Addendum No. 01

Issued: **20 Feb. 2026**

Project Name: **SJSD Albert R. Lyman Middle School**

Project No.: 2023554.01

C3 RECEPTION - W
SCALE: 1/4" = 1'-0"

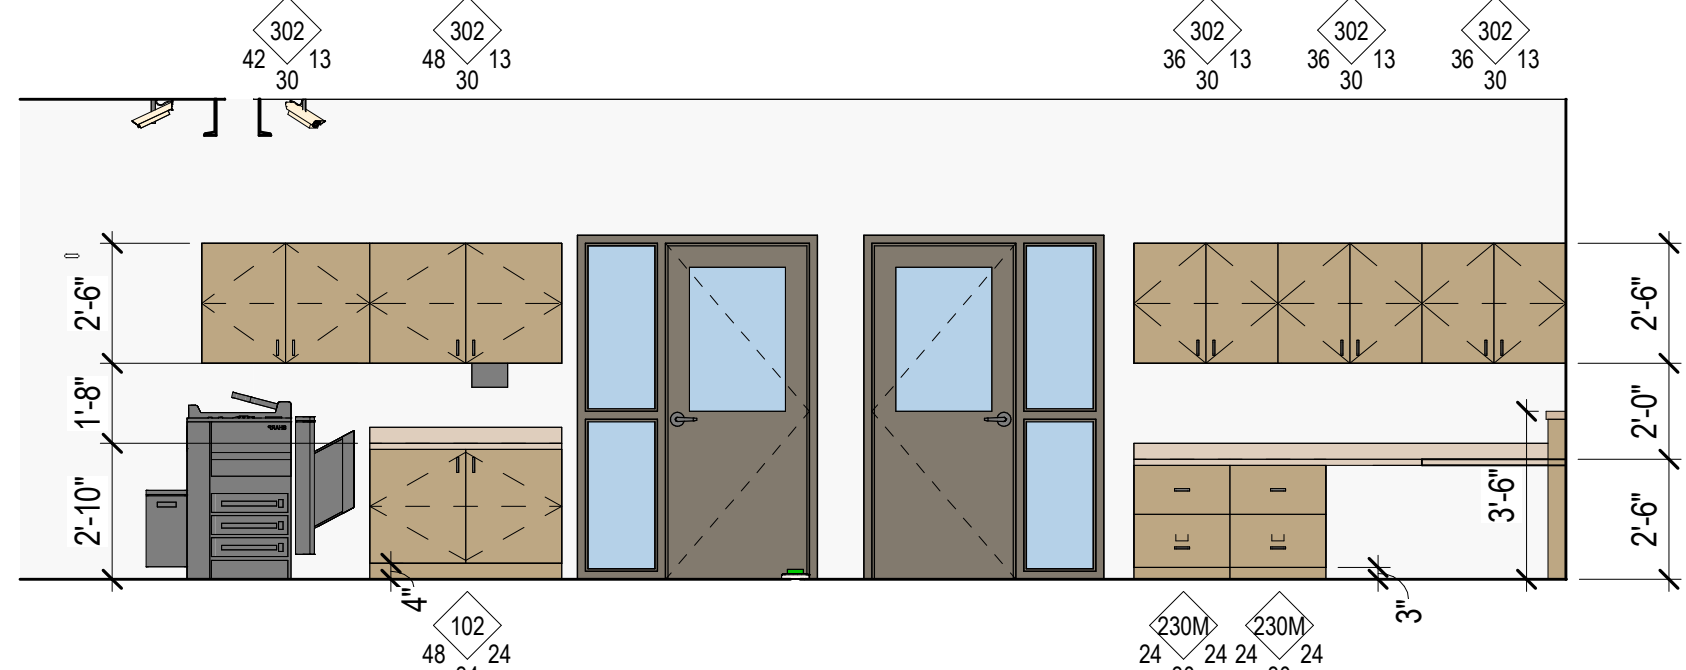
3. Added section callout to casework elevation C2, C3 & D3 to clarify size and construction of reception desk
 4. Re-print sheet to clean-up structural joists and mechanical ductwork that had been modeled too low into some spaces.

5. Added keynote 3 on C3 and C2 to provide finish casework privacy panel at window wall side of desk.
 6. Removed Elevation D1
 - 7.
- A1.12 Sheet A411 – Interior Elevations
